Cork Line Level Crossings
Consultation Report
Iarnród Éireann

Cork Line Level Crossings

Project No: 32111000
 Document Title: Consultation Report
 Document No.: CLLC Public Consultation Report
 Revision: 1
 Document Status: Final
 Date: June 2020
 Client Name: Iarnród Éireann
 Client No: TBD
 Project Manager: Alex Bradley
 Author: Lisa Halpin
 File Name: CLLC Public Consultation Report

Figure 2-1 XC211 Blue Route

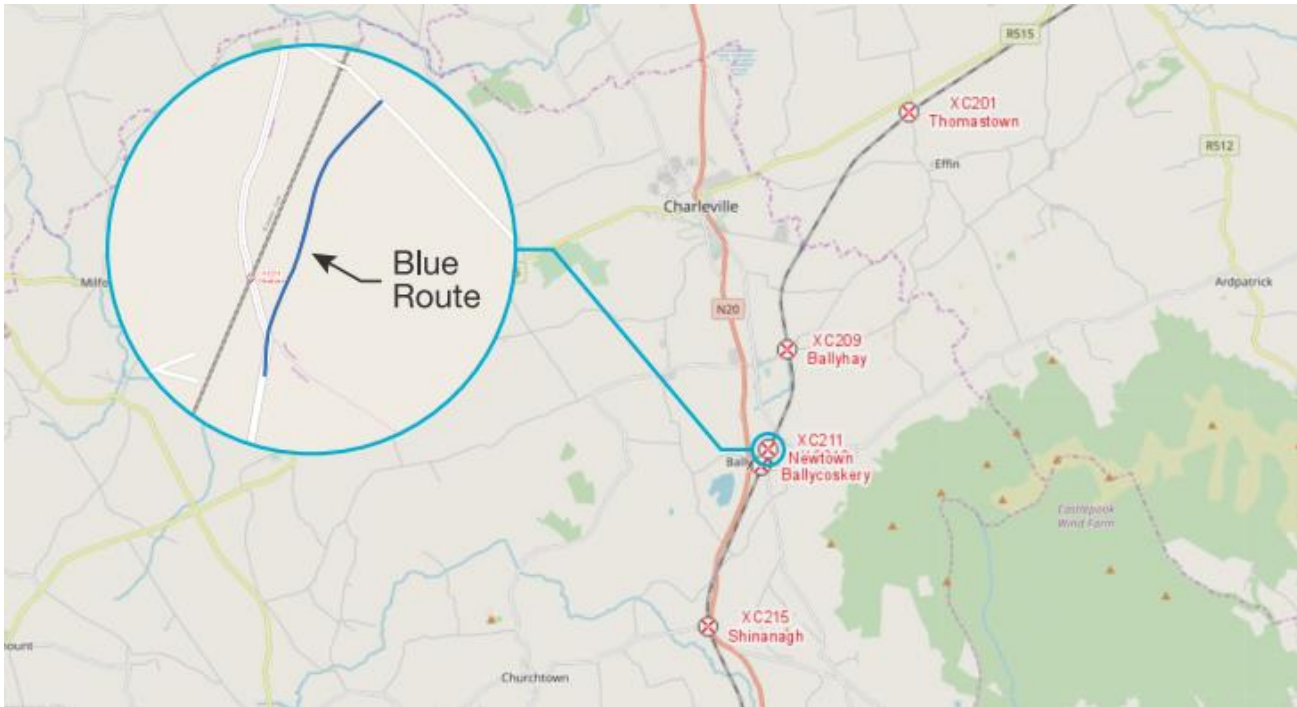
The overall sentiment of this further consultation was positive with many residents expressing their satisfaction that it was now proposed to change the preferred option for the elimination of level crossing XC211 Newtown, from the Green Route to the Blue Route.

One resident remarked "I would like to say that the revised proposal (the blue route) represents a significant improvement on the original proposal in that it avoids running a thoroughfare through a housing estate, avoids severance of the highly populated North side of the parish and the village; ensures easy access to the church,

school and community hall from the populous north side of the parish; avoids fragmentation and severance of the village." However, the resident also noted that "The above endorsement was made prior to taking sight of the official plans and drawings prepared by Jacobs" and "also made without reference to any possible impact on the red option proposed for Ballycoskery."

Another resident stated "having revived the revised plan for the proposed closure of Newtown Level Crossing XC211 – I am happy that this is a considerable improvement." However, they also commented that they "would however like to see specific plans and drawings of the new proposal."

Another resident stated "I have reviewed the revised plan for the proposed closure of Newtown Level Crossing, XC211 which introduces a new road from Newtown Bridge to the present level crossing on the east side of the railway line and I am in agreement that it represents a marked improvement on the original proposal." This resident also stated "what I have reviewed is not the final plans and drawings for the new proposal and would like to be kept informed of future developments."

Ballyhea National School commented on the revised proposed solution for XC211 Newtown. In their submission they stated "the revised proposed solution (blue solution) appears to be more consistent than its antecedent in that it allows for a greater ease of access to Ballyhea National School from the northern side of the parish. Without such an ease of access, an adverse impact on the school's catchment area could be foreseen with some parents availing of easier access to schools in Charleville."

The trustees of Ballyhea National School (the landowners) also submitted to this period of further consultation echoing the sentiment of the Ballyhea National School submission. They stated that they "wished to indicate a greater satisfaction with the revised proposed solution for the eventual closure of the level crossing at Newtown (XC211)." They added "the first proposed solution lacked all credibility from various perspectives, including health and safety norms and exhibited poor liability management." They added that "the revised proposed solution has the benefit of conserving accessibility to the school and community hall from the north and also accessibility to the sporting facilities at Ballyhea GAA."

Their submission did note that "it would be necessary however to minimise the environmental impact of the new road on the east side of the railway line from the Newtown bridge to the present level crossing." Finally, the Board of Trustees stated that their submission "is made with the proviso that no detailed plans or drawings have been made available for inspection and no statement has been made with regard to its possible impact on the proposed red solution at level crossing XC212."

In relation to XC211 Newtown, the Blue Route was defined and appraised as part of the Route Options Report (Appendix D of the Preliminary Design Report), which is available on the Irish Rail website. This further consultation on XC211 Newtown announced a change of preferred route, which provides a new link to the road east of the railway corridor to connect the local road at the east side of the level crossing, XC211, with the local road to the north east of the level crossing thus providing an essential continuation of connectivity to local amenities.
